# AI-2025-A40-B40-C80,共10套

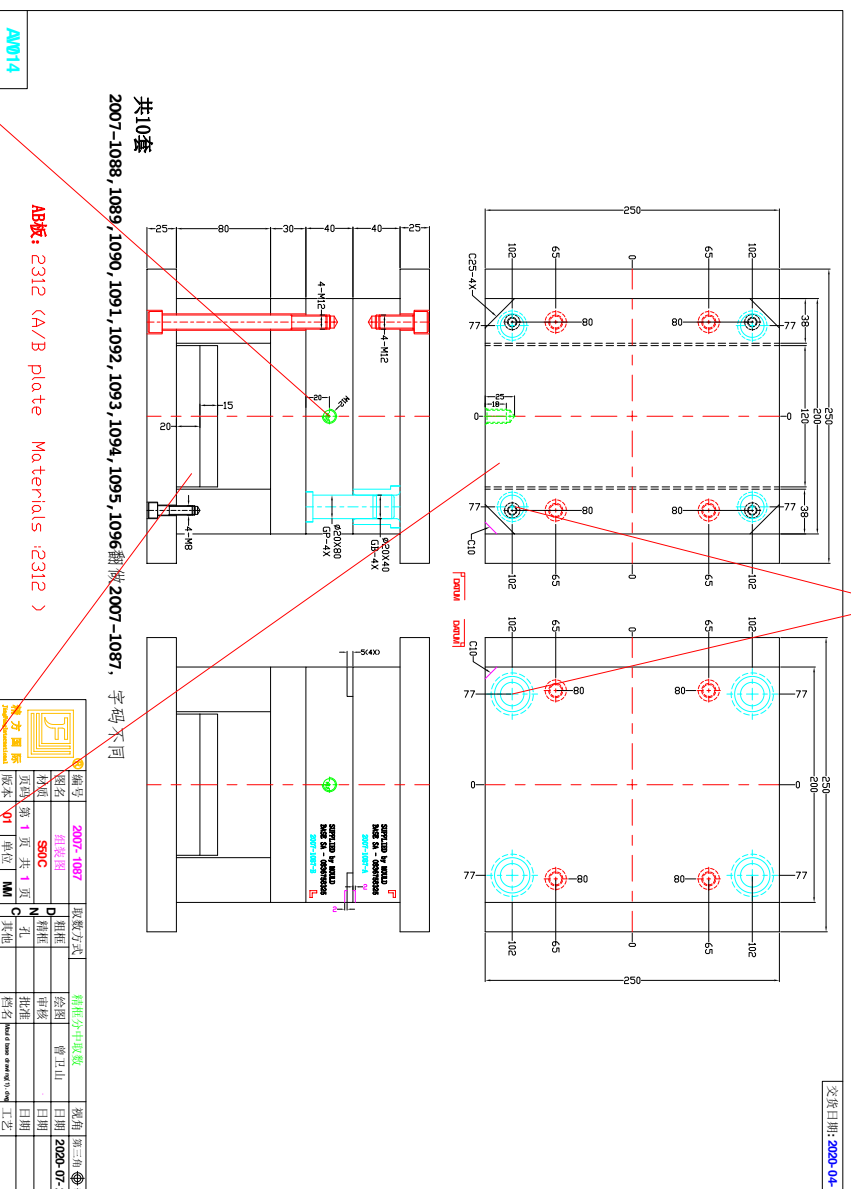
The position of the four pillars is the same .no offset

Only need one eyebolt hole in the B Plate.

No screw holes in the ejector plate, and don't need to make return pin holes
